**KING'S MARK  
ENVIRONMENTAL REVIEW TEAM**

**REPORT FOR  
CASTLE LANE SUBDIVISION  
ANSONIA, CONNECTICUT**

Environmental Review Team Report

JULY 1988

**PROPOSED  
SUBDIVISION  
NORTH SECTION**

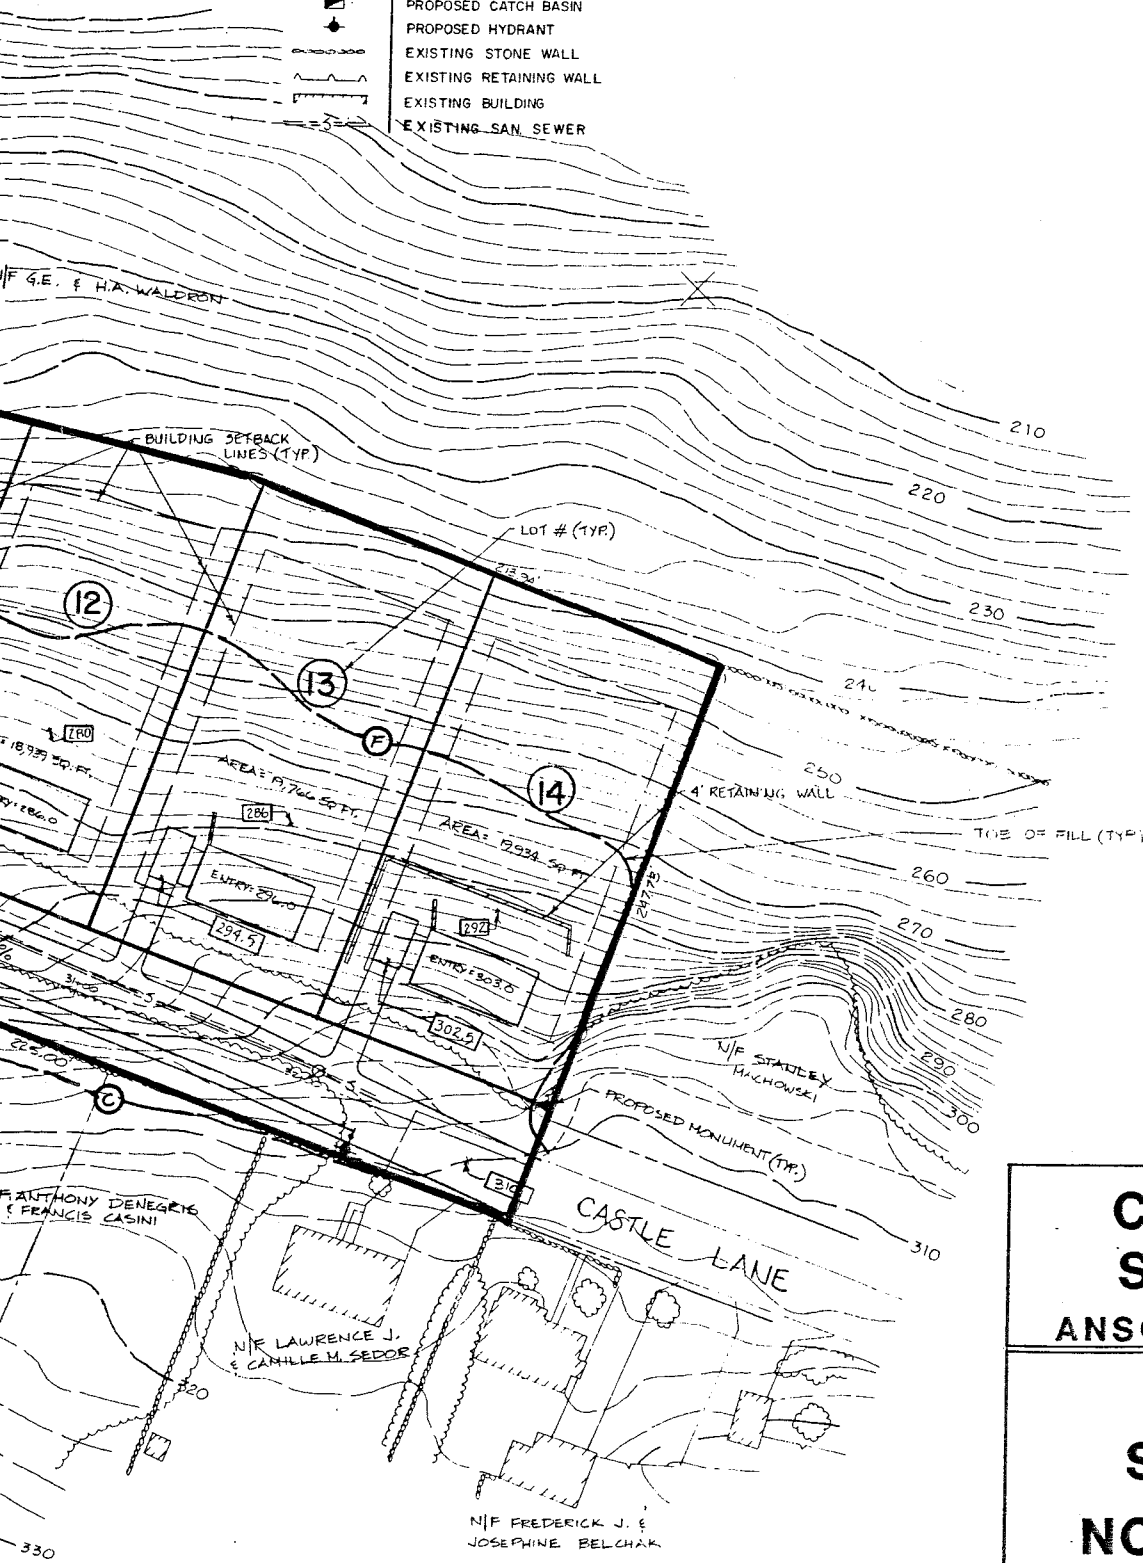
The proposed subdivision would encompass 24 house lots. Extensive cuts and fills will be needed. A single road is proposed to serve the subdivision and will connect Castle Lane with Granite Terrace. The subdivision would rely upon municipal sewers and water.

Shallow bedrock on the site may require blasting. Blasting should be done with the state-of-the-art technology due to the high density residential land use. The major concerns would be flyrock, ground vibrations, air-blast, dust and gases. A pre-blast survey is highly recommended and a thorough blasting record should accompany the survey. Some methods that can be used to reduce the potential environmental impacts of the blasting include blasting to an open face, multiple small charge blasting and use of a millisecond delay between detonations. This will depend on the blasting requirements of the site. Some of the driveways may need blasting to lessen the slopes. The blasting will raise the cost of building these lots.

Due to the steep slopes and the location on the north side of a hill, driveways may experience winter icing conditions. Careful planning should address this concern. On the steeper lots, it may be wise to have a geotechnical engineer study whether or not the unconsolidated materials can support house foundations. The steep slopes will restrict the use of heavy equipment in some areas.

**TOPOGRAPHY**

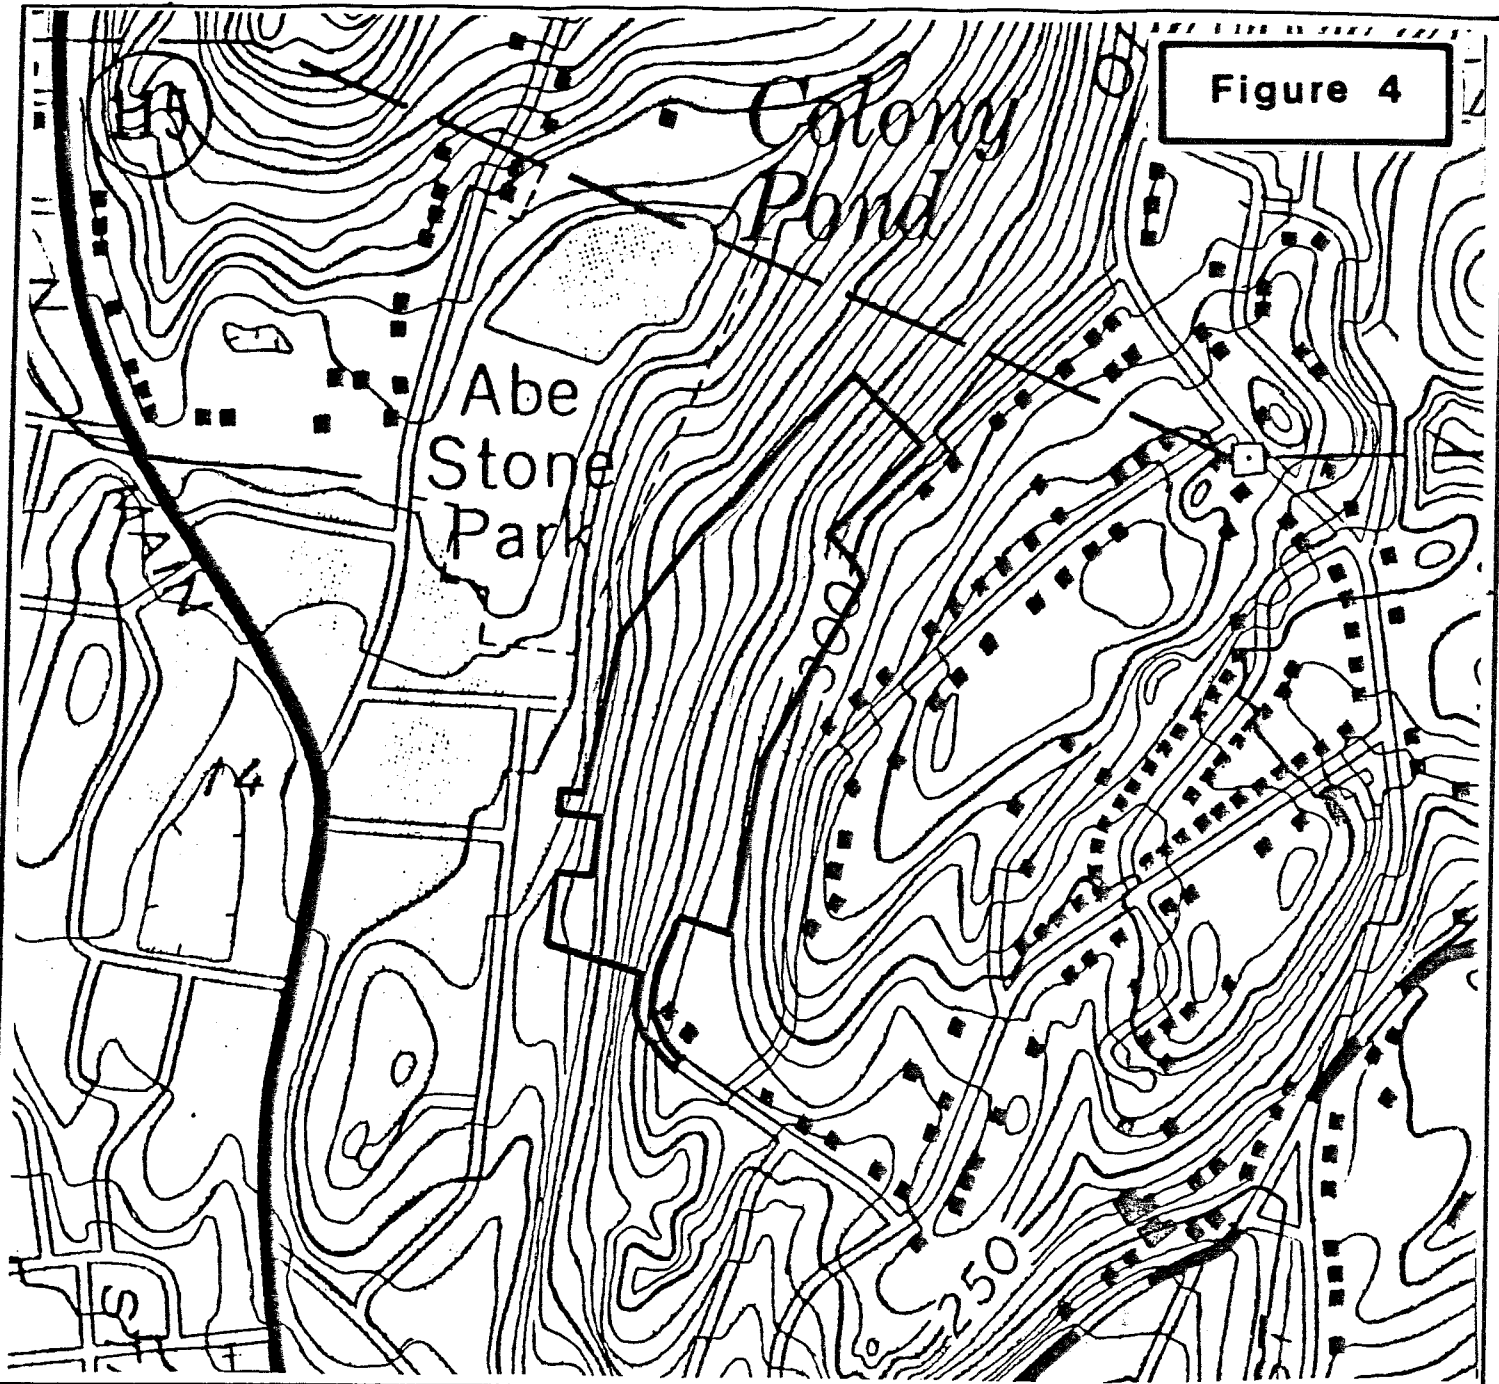
range from 150 feet above mean sea level along the western border to 310 feet above mean sea level along the eastern border (see Figure 4). Numerous large surface boulders are common throughout the site.

**SURFICIAL  
GEOLOGY**

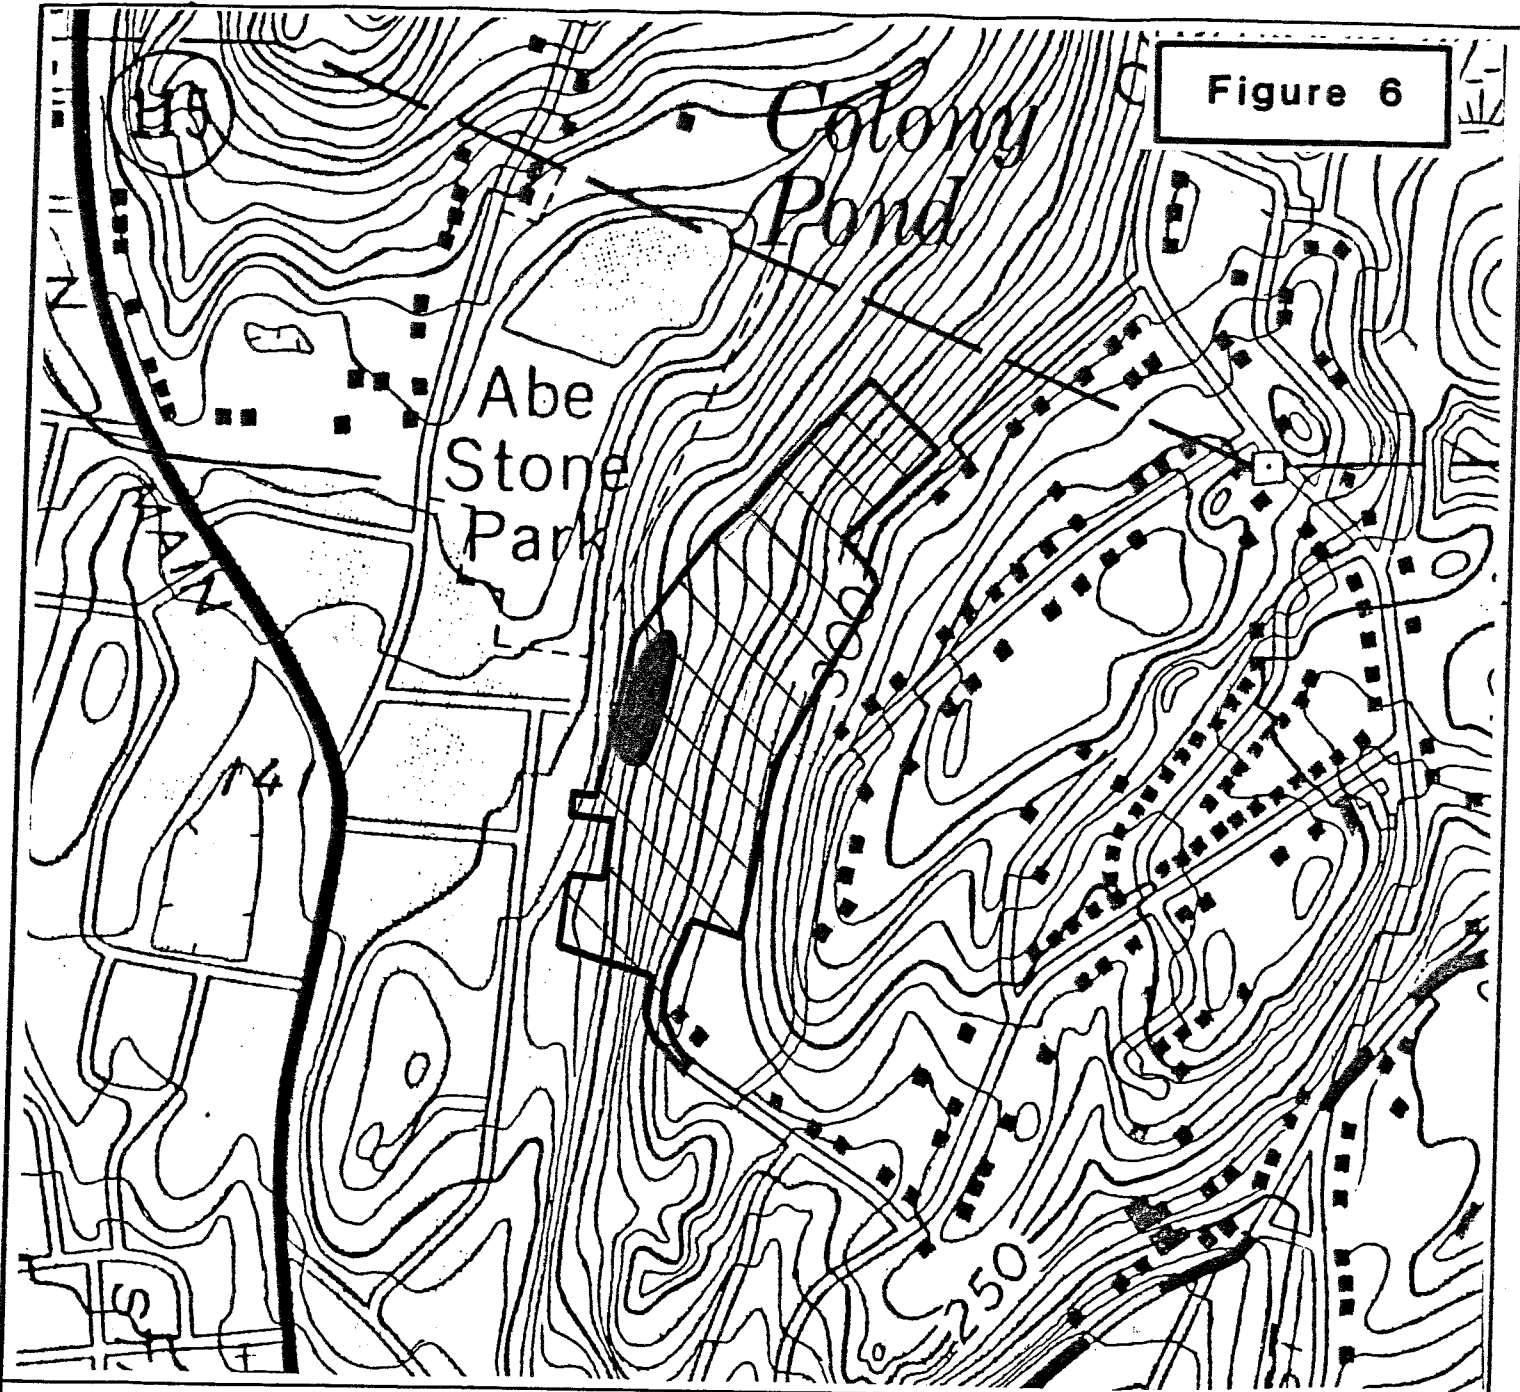
The surficial geologic materials, called till, consist of a light gray mixture of sediments ranging in size from clay size particles to large boulders, but predominantly sand and silt (see Figure 6). Based on soil mapping information, the texture of most of the till on the site is generally sandy and loose. As mentioned earlier, numerous large surface boulders have been strewn on the property by the glacier. The till sediments were deposited by glacial ice as it moved across the bedrock surface from north to south-southeast. It is 10 feet thick (or less) in most places.

**WATERSHED  
HYDROLOGY**

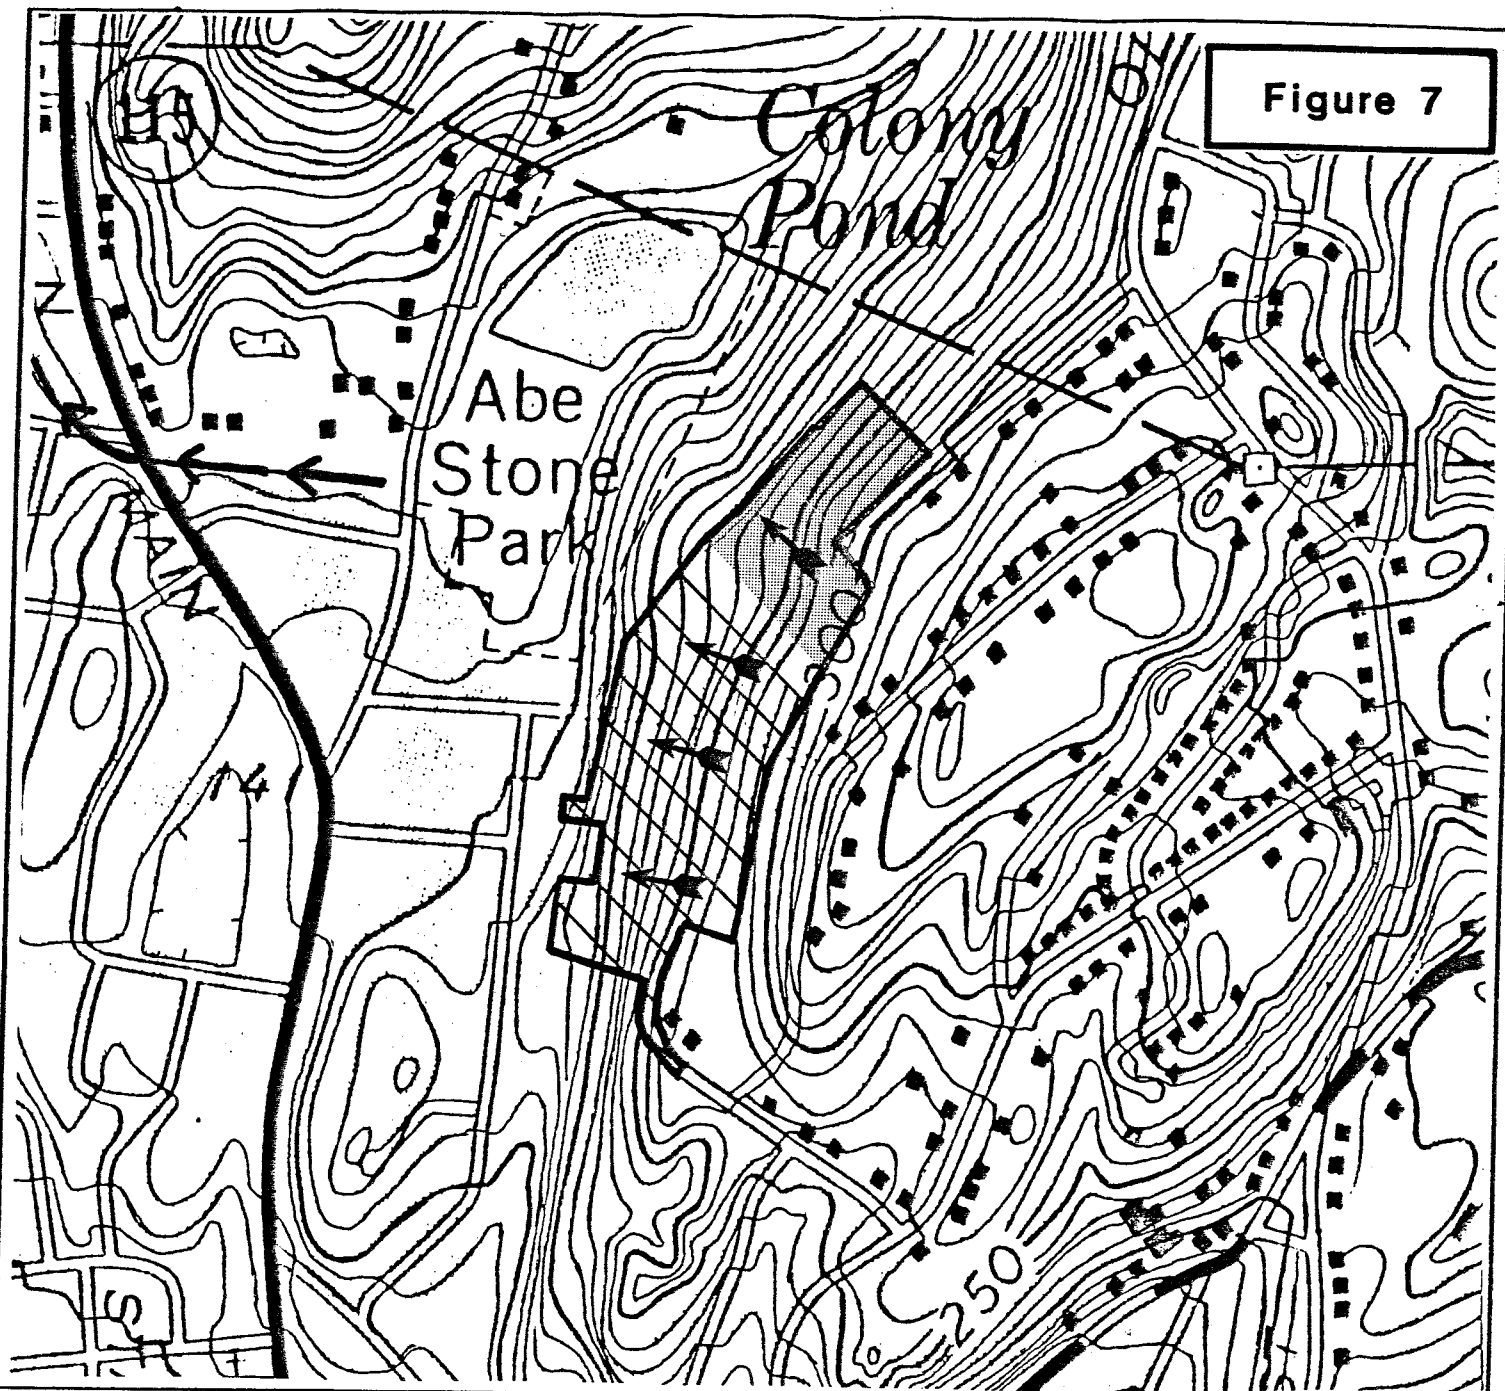
Under present conditions, the northern parts of the site drain west/northwest to Colony Pond via seasonal drainageways. The remainder of the site drains westward to the outlet stream for Colony Pond (see Figure 7). Surface runoff in the watershed which is generally east of Woodlawn Avenue and which includes the southern and central parts of the subject site, is presently intercepted by storm drainage and routed via a 12" storm drain in Gardners Lane

and Colony Street. The water is outletted to a man-made ditch, which is west of Abe Stone Park and which terminates at North Main Street. From North Main Street to the Naugatuck River, the watercourse consists of an open, natural channel paralleled by wetlands/floodplain. Based on present plans, it appears that following development, runoff from the northern parts (east of the access road) would be intercepted by road drainage and routed to the storm drains in Gardners Lane.

The two major concerns with increased runoff are the potential for flooding and streambank erosion. Team members were informed during the field review that flooding problems exist along the outlet stream for Colony Pond. The applicant's technical staff have addressed in a report made available to Team members, how they plan to handle post-development runoff increase. Because of the steep slopes that prevail throughout the site, the use of on-site detention basins does not appear to be a feasible solution for controlling post-development flows from the site. Instead, the applicant has proposed to upgrade the storm drain in Gardners Lane and Colony Street (to the beginning of the man-made ditch) from a 12" diameter pipe to an 18" to 30" pipe to handle the anticipated post-development runoff increases. The final storm drainage plan and pipe sizing needs to be carefully checked by the City engineer to ensure that existing flooding conditions are not worsened.
